DRAINAGE SUMMARY

PROJECT : INTERSTATE ROUTE H-3

F. A. I. PROJECT NO: 1 - H-3-(150)

STATE OF HAWAII DEPARTMENT OF TRANSPORTATION HIGHWAYS DIVISION
DRAINAGE PLAN
INTERSTATE ROUTE H-3 F.A.I. PROJ. NO. I-H3-1(50)
SCALE: 1" = 40' DATE: JUL., 1988
SHEET No. H8 OF 54 SHEETS

INLET STRUCTURE AT STA. 485+27.91 ± o/s 125.28' RT.
Scale: 1/8" = 1'-0"

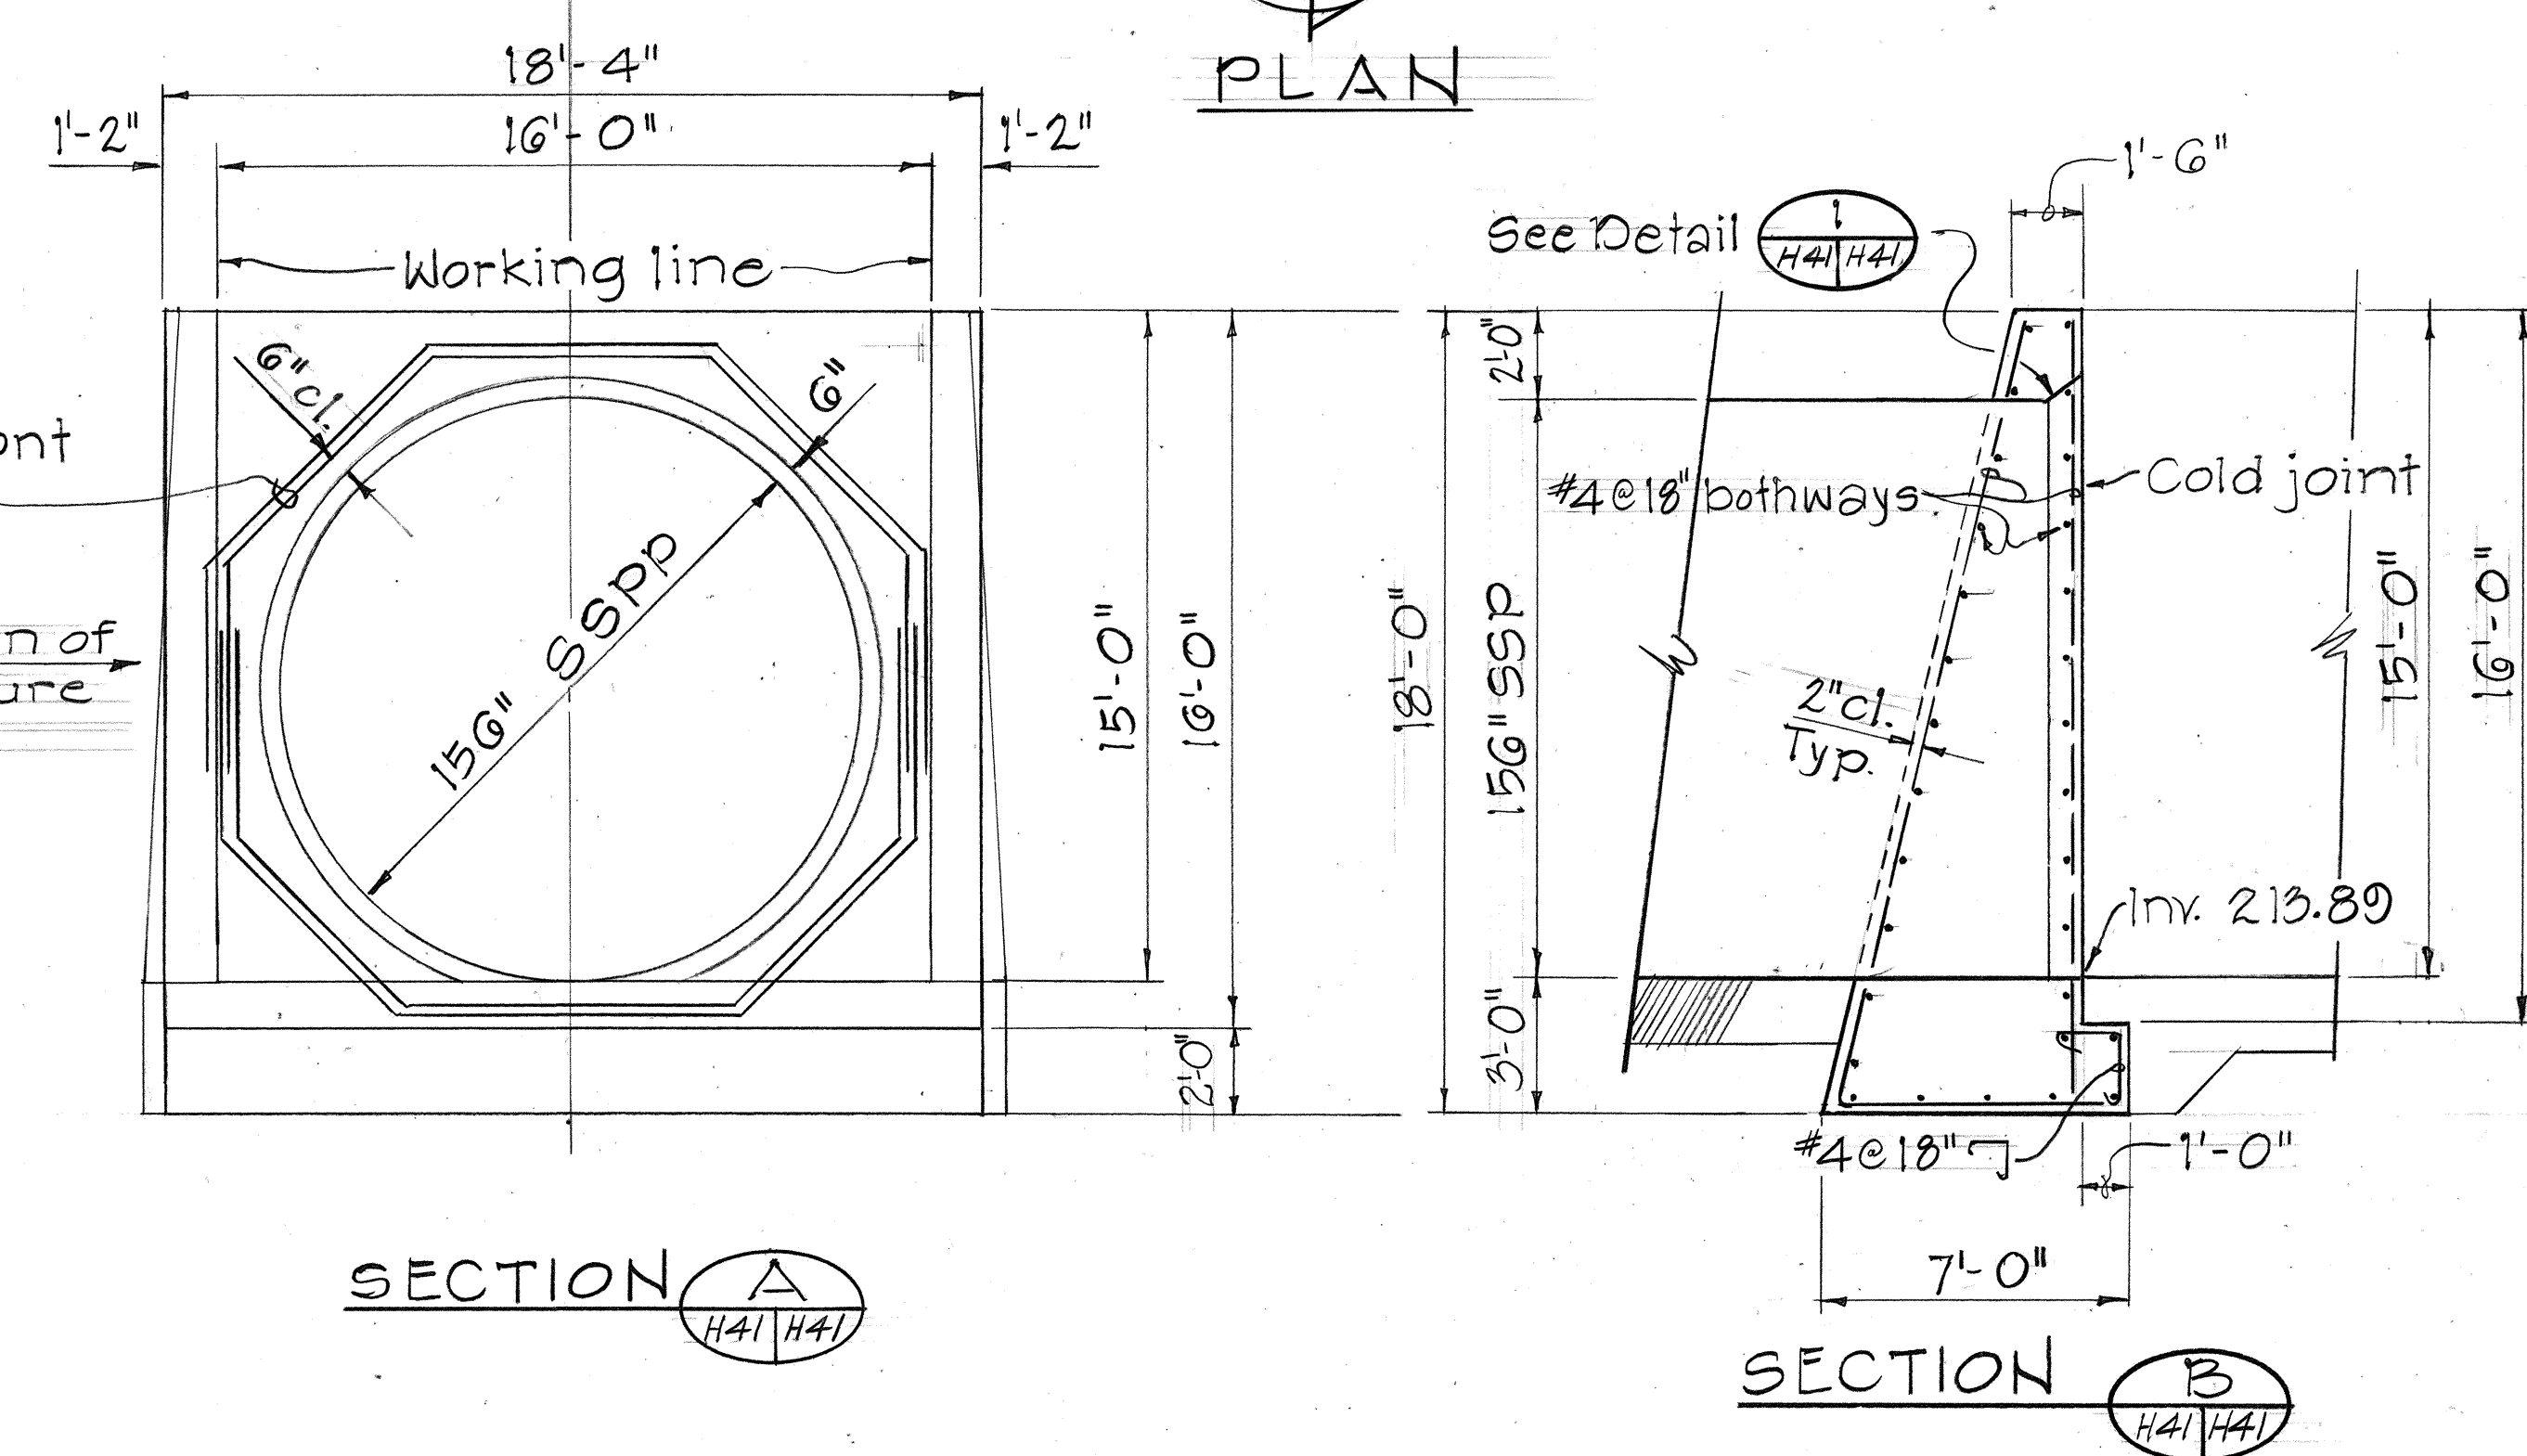
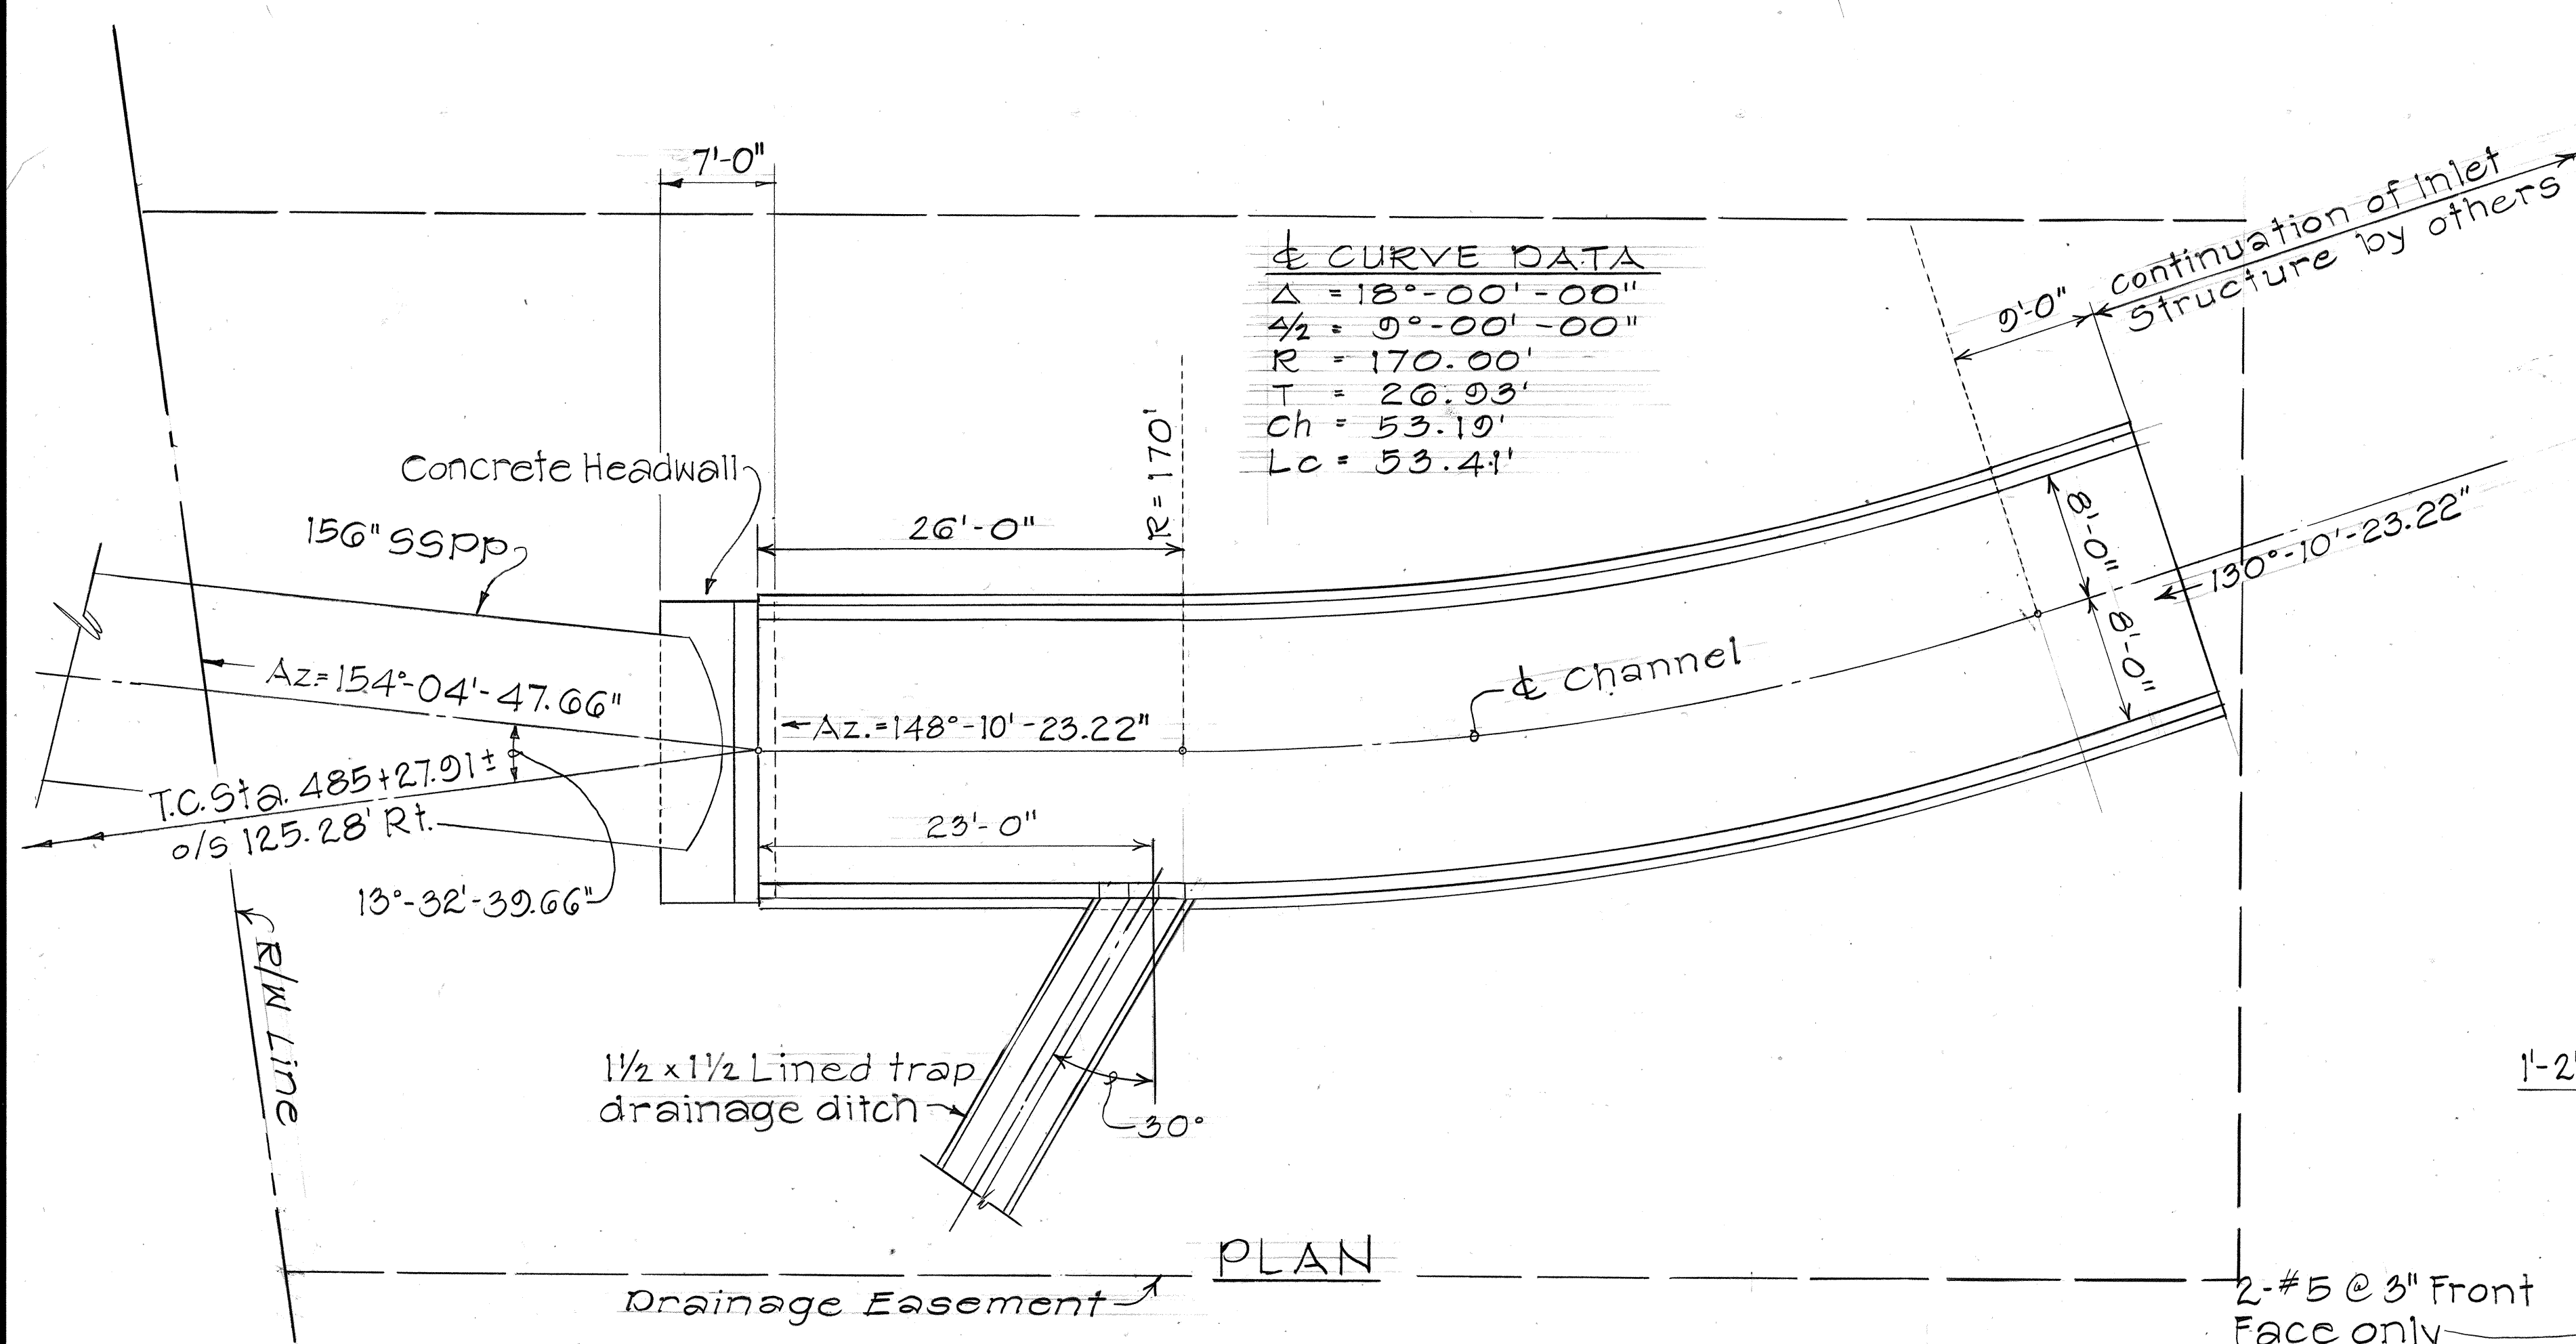
DATE	REVISION
6/12/90	Revised Inlet Structure design.

CLASS B BEDDING TRENCH DETAIL FOR CULVERT CROSSINGS

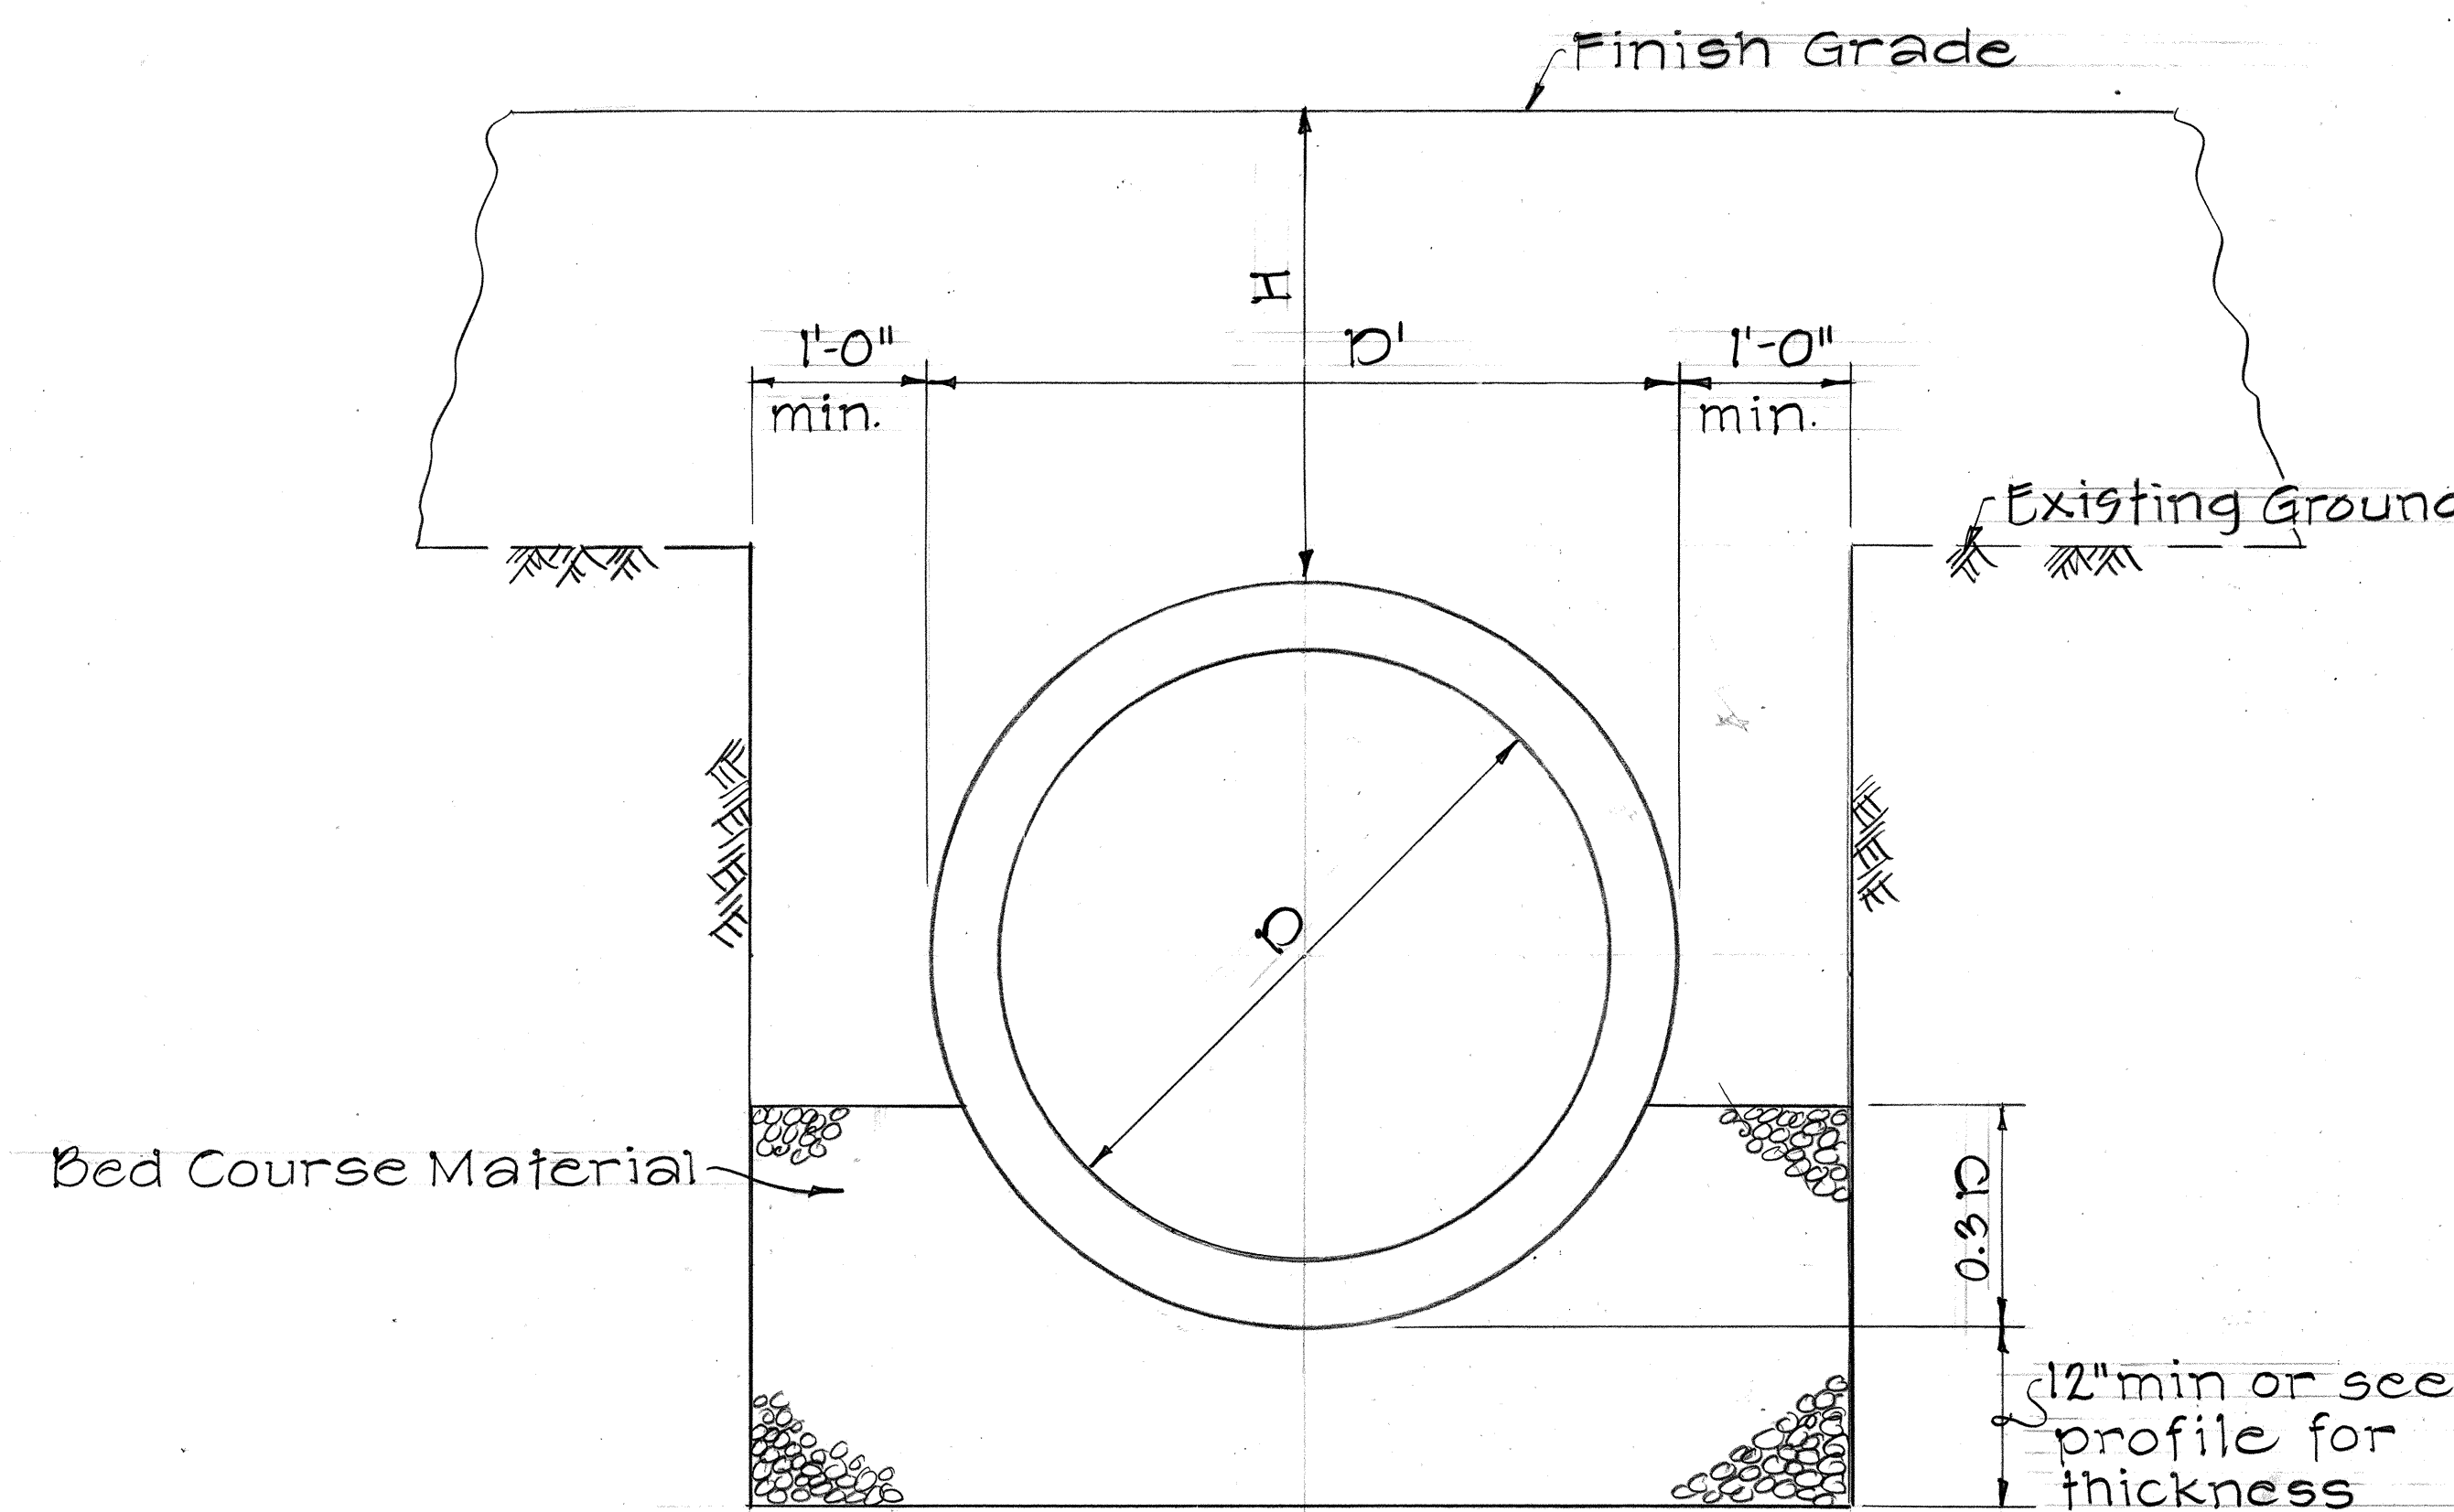
8/31/90	Deleted Grass Swale added Earth Ditch
1/4/89	Sheet revised to show detail of Grass Swale
DATE	REVISION
